Re: Task 3 Dam Assessment Report
Project #0-381
Allen Steam Station Coal Ash Retention Dam
Belmont, North Carolina

FINAL REPORT

ALLEN STEAM STATION COAL ASH RETENTION DAM
BELMONT, NORTH CAROLINA

**#4 Local Erosion on Top of Downstream Stability Berm –
Southern Portion of East Dike**

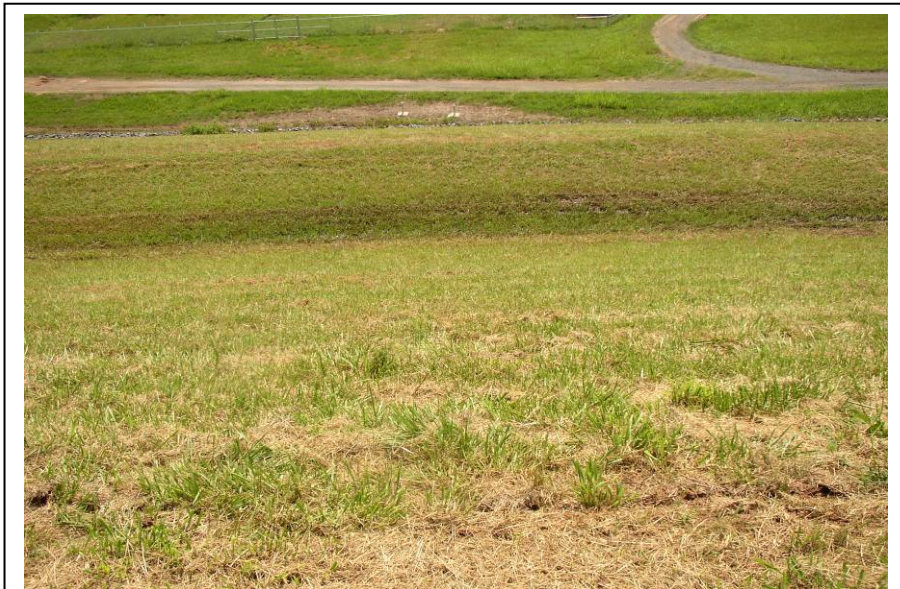
The downstream slope of the dike consists of an upper section with a [redacted] and a low section (stability berm) having a slope [redacted]. There is [redacted] wide stability berm at elevation [redacted]. The slopes are grassed with occasional [redacted] low shrubs along the dam. The toe of the embankment is of rockfill constituting the daylighted section of the blanket toe drain that was constructed when the berm was added. The riprap was observed to be in good condition; clear seepage with a flow rate of less than one gallon per minute was observed at several areas along the rock toe drain. Ponded surface water was observed east of the downstream toe near the outlet and locally on the berm; this water is attributed to the recent heavy rains.
